**Planning ref LCC/2023/0030 Sand and Gravel Extraction Bourbles Farm,
Bourbles Lane, Presall**

**Lancaster Road Quarry Boundary Residents Association
Objection to the revised Transport Statement of December 2024**

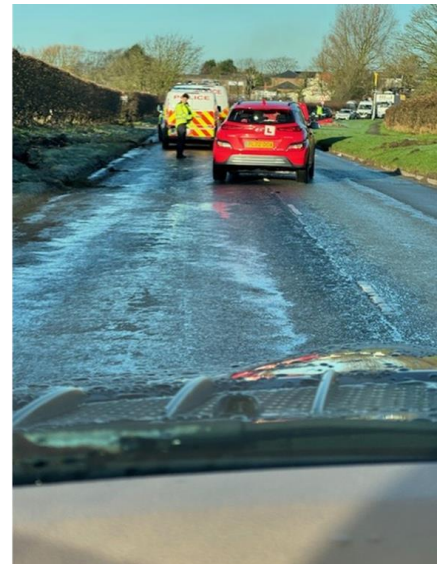
- 5.4 While the commitment to avoid school traffic times is acknowledged, the developers' proposed non-operating hours do not align with the actual school and bus schedules. On Lancaster Road, seven St Aidan's school buses operate between 07:15 and 08:15, and eight between 14:15 and 14:45, times that are not fully covered by the developers' plan. Similarly, Stalmine School operates between 08:00 and 09:00 and closes at 15:20, further highlighting the

discrepancy. Therefore, the window that the site would not operate on would need to be much wider. Additionally, the proposal fails to address risks to pedestrian safety and the noise and vibration impacts on residents during other operating hours.

A588 at Stalmine

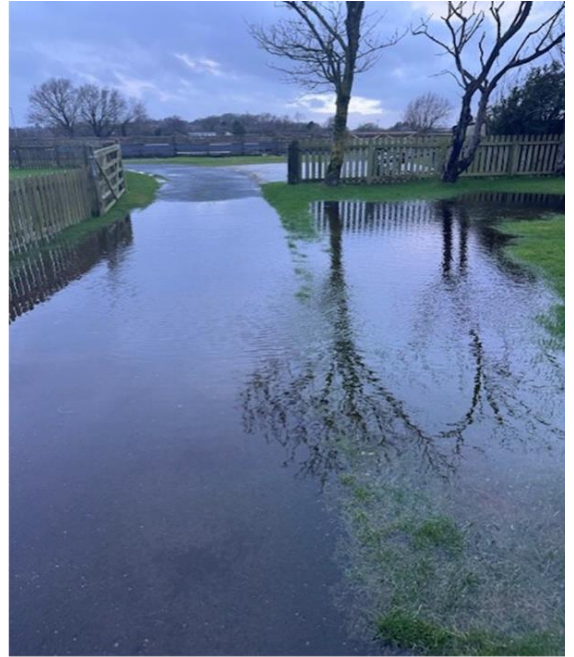
Indeed as recently as 1st January 2025 the A588 at Stalmine was flooded and a number of vehicles became stranded. The road was out of use and eventually closed for the best part of the day. Traffic was then diverted around the back lanes and also became 'stuck' due to flooding on these 'back roads'. Other routes that would be used by quarry traffic i.e. Garstang Road to access the A6 and Cockerham Road again providing access to the A6 were both unsurpassable - making the whole area somewhat inaccessible.

The proposal to asphalt the full length of the new access road has failed to consider the significant implications for an area already prone to flooding. Specifically in terms of Lancaster Road, existing drains are unable to cope even with light rainfall, as evidenced below and exemplifies this issue. The drainage challenges on Lancaster Road worsened notably after the road surface repairs and we have several photos at different times of the year demonstrating the frequency of this occurrence.

Furthermore, the risk of dykes overflowing and flooding the road, as well as the surrounding land owned by neighbouring landowners, has not been addressed. The entrance to the new access road will **remove the dyke or require a solution for HGVs to cross over a considerable length of the dyke** that currently runs along Lancaster Road. No information has been provided on how this will be addressed. Crucially, in addition, no details have been provided on how the construction of the new access road, which is now planned to be asphalt its full length will affect the drainage system. A relevant precedent is following tarmacking a small section of driveway at Hillfield House, their garden now floods several times a year. Has the impact of introducing such a large non-porous surface been adequately assessed in this context?
